Re: Case No. 16-253-GA-BTX
Staff Report Condition No. 8 – In Water Work Restriction Waiver

**Subject: Request for Waiver of In-Water Work Restriction
Duke Energy C314V Central Corridor Pipeline Extension, Hamilton Co., Ohio
LRH-2020-351**

C314V Central Corridor Pipeline Extension Project

FIGURE 1 - 3
PROJECT PLAN AND
WATER RESOURCES

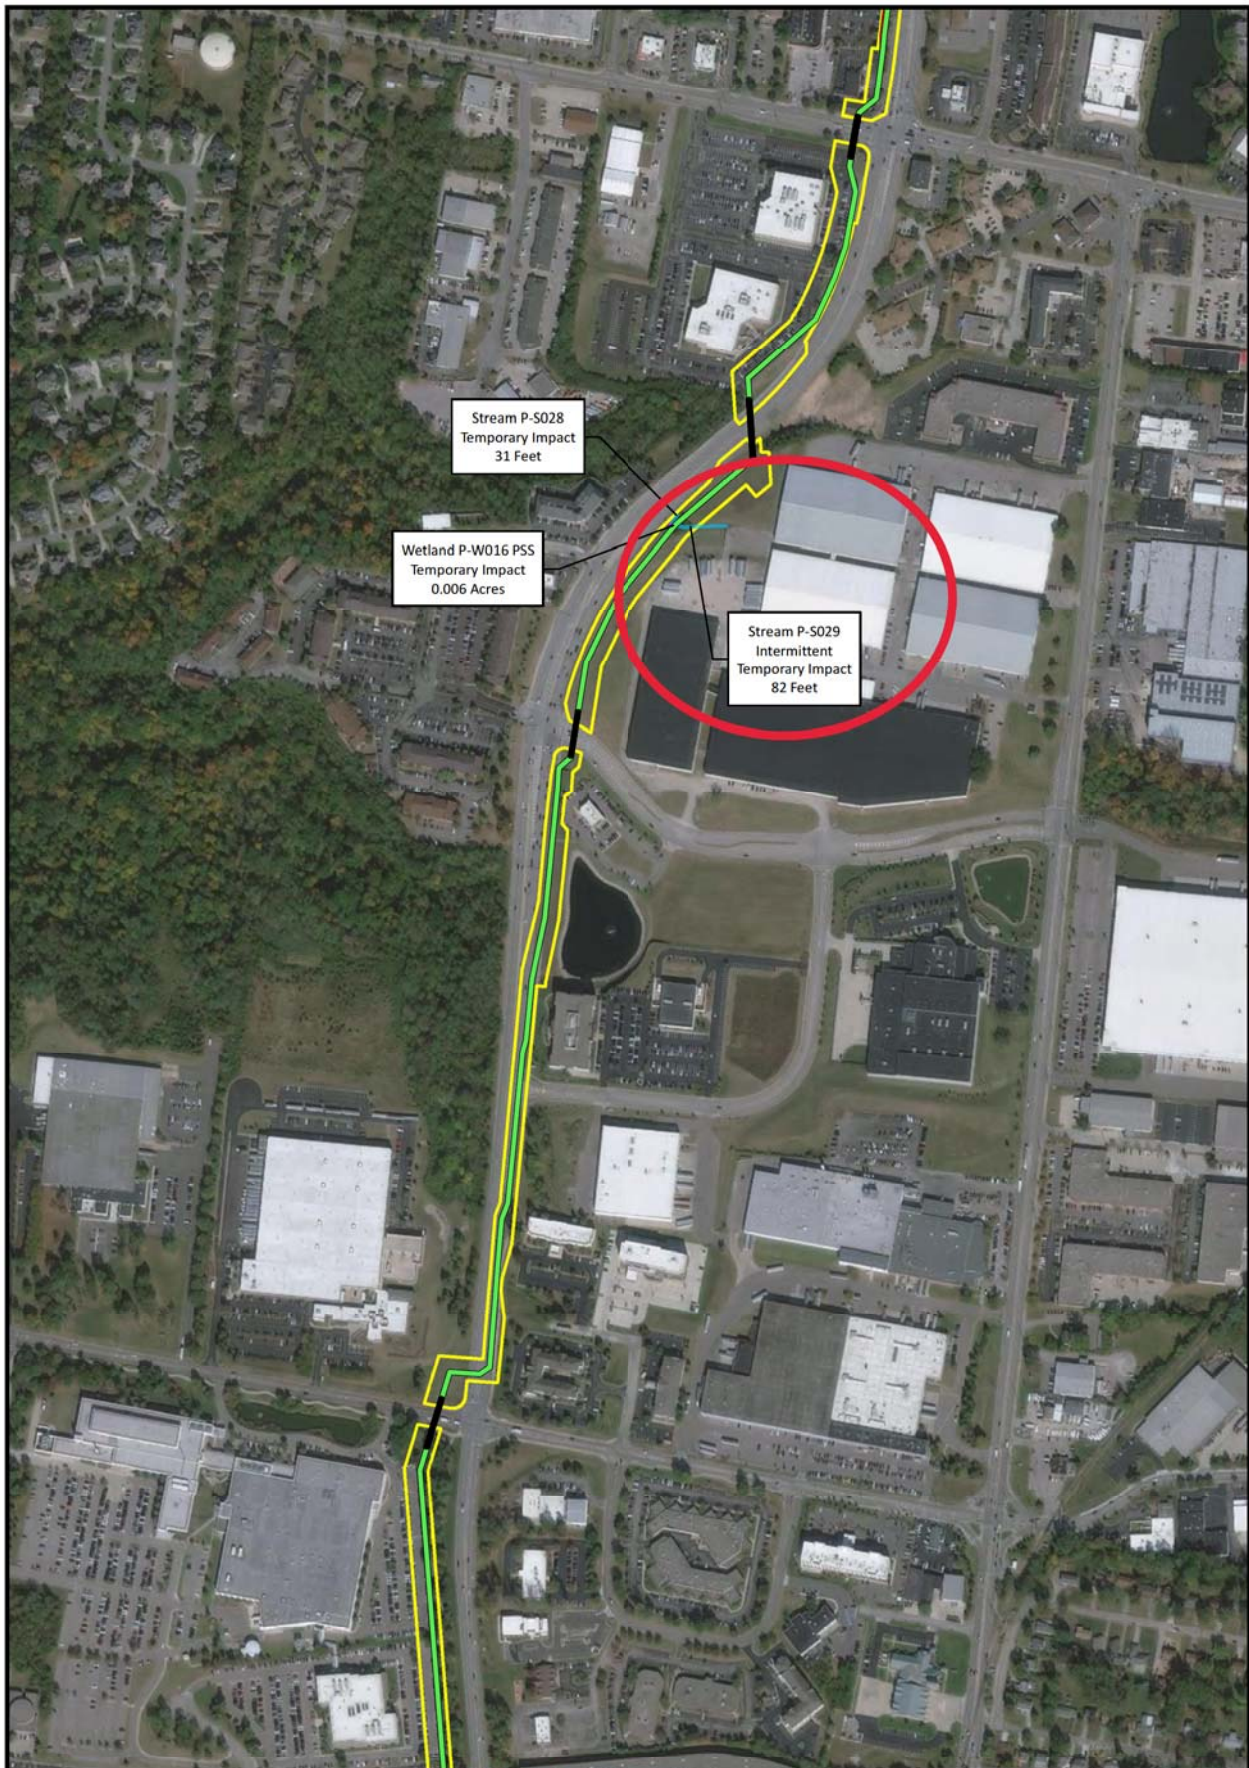
The stream reach is an Unnamed Tributary to Sharon Creek (headwater stream). Refer to Figure 1-3 map sheet for a map illustration. Approximately 54 meters of stream were assessed. The stream was dry and contained no flow or pools during the field review. Dominant substrates within the reach included cobble, gravel, and silt. Due to the small watershed size and lack of flow, the probability of this stream reach supporting mussels is not likely.

The project is eligible for a full waiver. Therefore, in-water work can occur at any time during the restricted period of April 15 through June 30, 2021. However, in-water work should be limited to only that which is necessary, and completed as soon as possible once started.

FIGURE 1 - 10
PROJECT PLAN AND
WATER RESOURCES

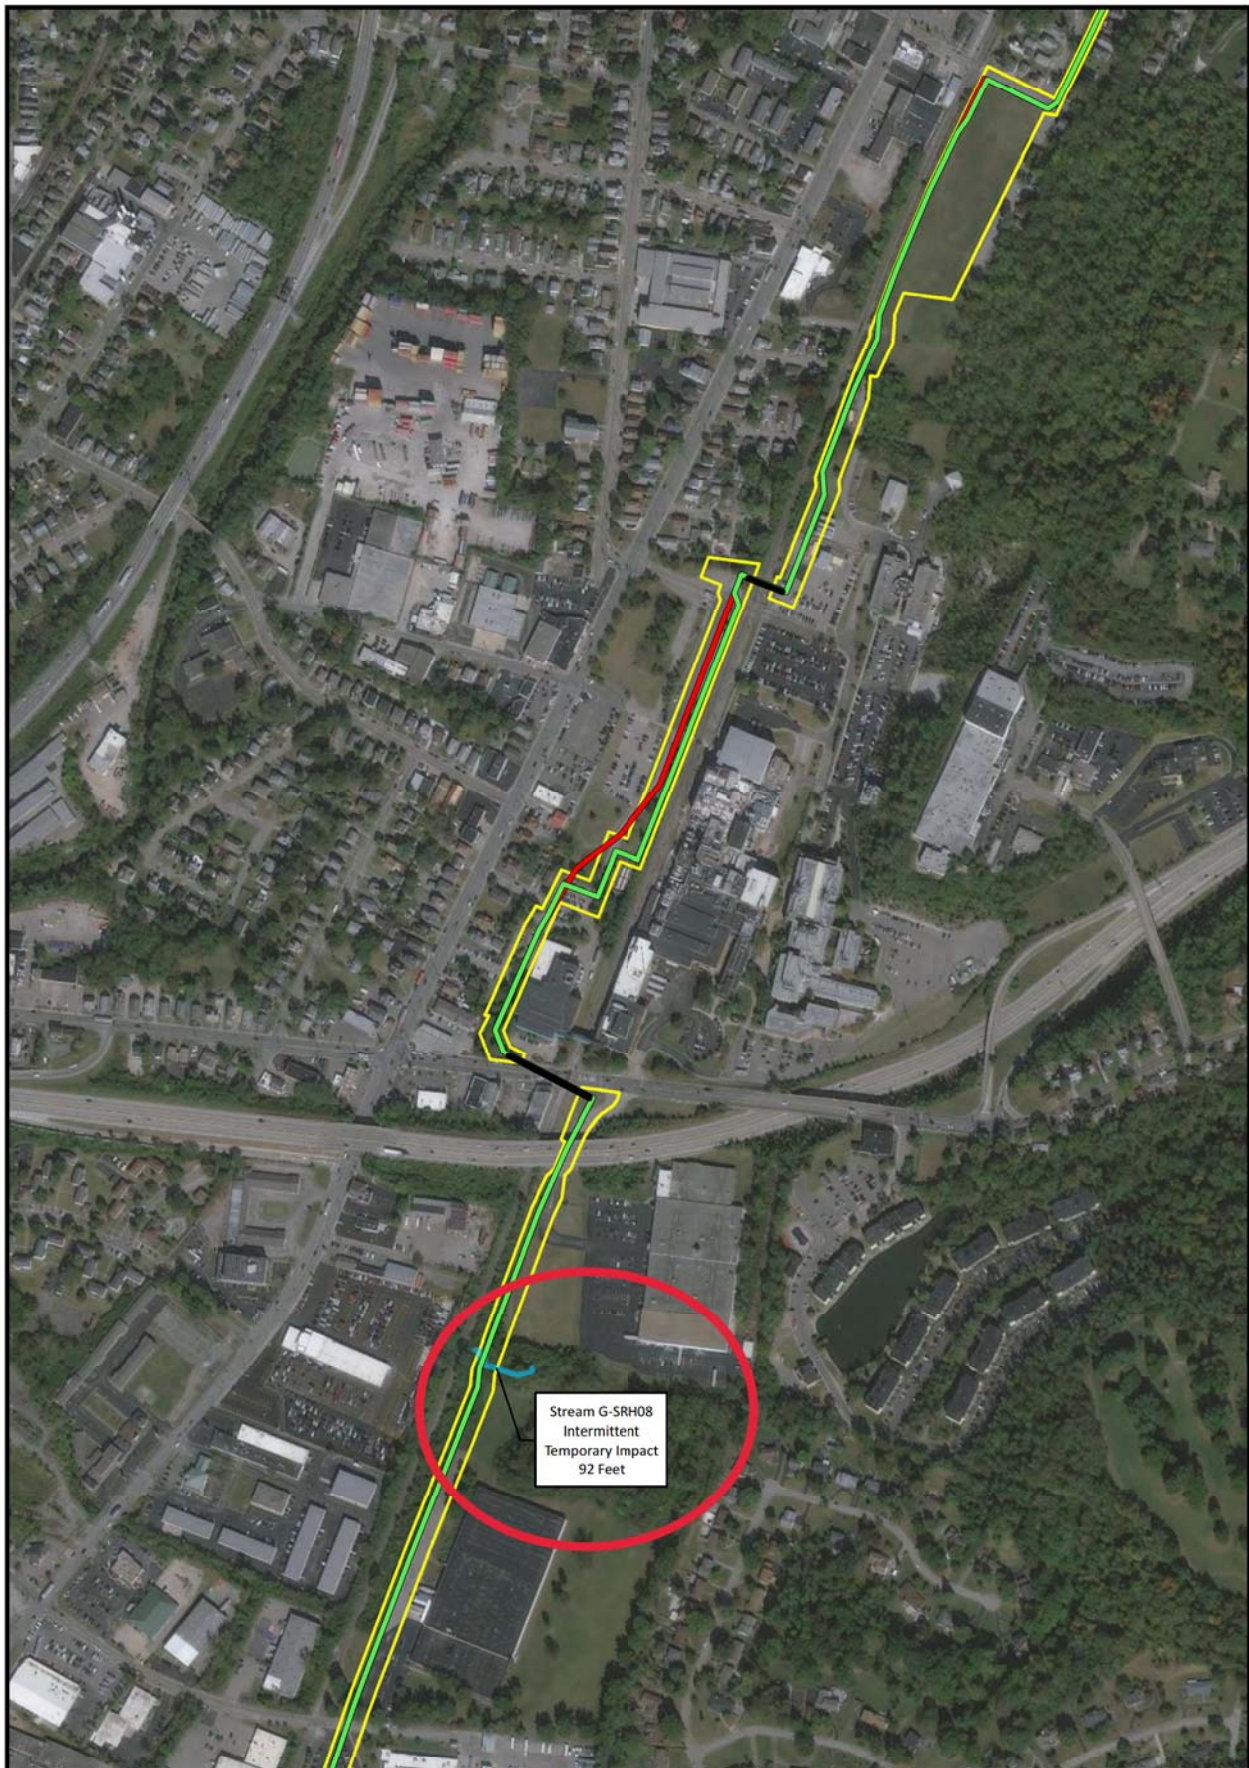
This stream reach is an Unnamed Tributary to Mill Creek (headwater stream). Refer to Figure 1-10 map sheet for a map illustration. Approximately 70 meters of stream were assessed. The stream contained flow during the field review. Dominant substrates within the reach included silt and gravel. Due to the presence of flow, a mussel reconnaissance survey was performed. No signs of mussels were present. Due to the small watershed size and results of the mussel reconnaissance survey, the probability of this stream reach supporting mussels is not likely.
